Docket Item # 8  
BAR CASE # 2008-0252

BAR Meeting  
March 4, 2009

**ISSUE:** Addition

**LOCATION:** 209 South Fairfax Street

Figure 10: Existing West and North Elevations

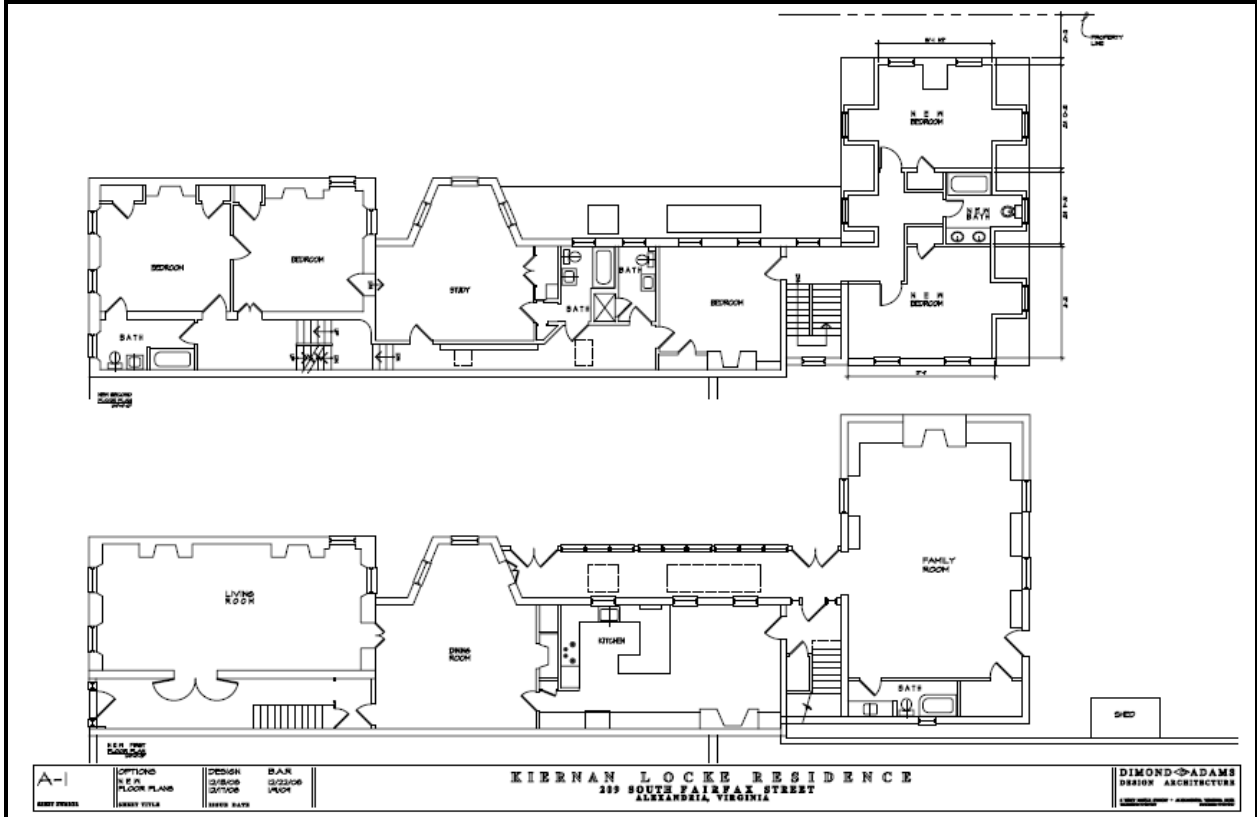
While single-glazed, true-divided-light windows are preferable, the *Design Guidelines* and the Board generally allow for double-insulated, simulated-divided-light wood windows and doors on new construction or in areas with limited visibility. Staff also does not object to the use of casement windows on the north elevation. However, Staff notes that these two windows are

proximate to the north property line in violation of building code requirements. The applicant intends to secure an easement from the adjacent property owner to prevent construction within three feet of these windows and will seek approval from Code Administration to permit the proposed windows. If the windows are not permitted, the wall design will need to be revised to eliminate the windows. Staff recommends that if the windows proposed along the north elevation are not permitted by building regulation that the applicant revise the design to provide recessed brick panels to simulate closed window openings in place of the proposed windows.

Staff recommends approval of the application with the condition that if the windows proposed along the north elevation are not permitted by Code Administration that the applicant revise the design to provide recessed brick panels to simulate closed window openings in place of the proposed windows.
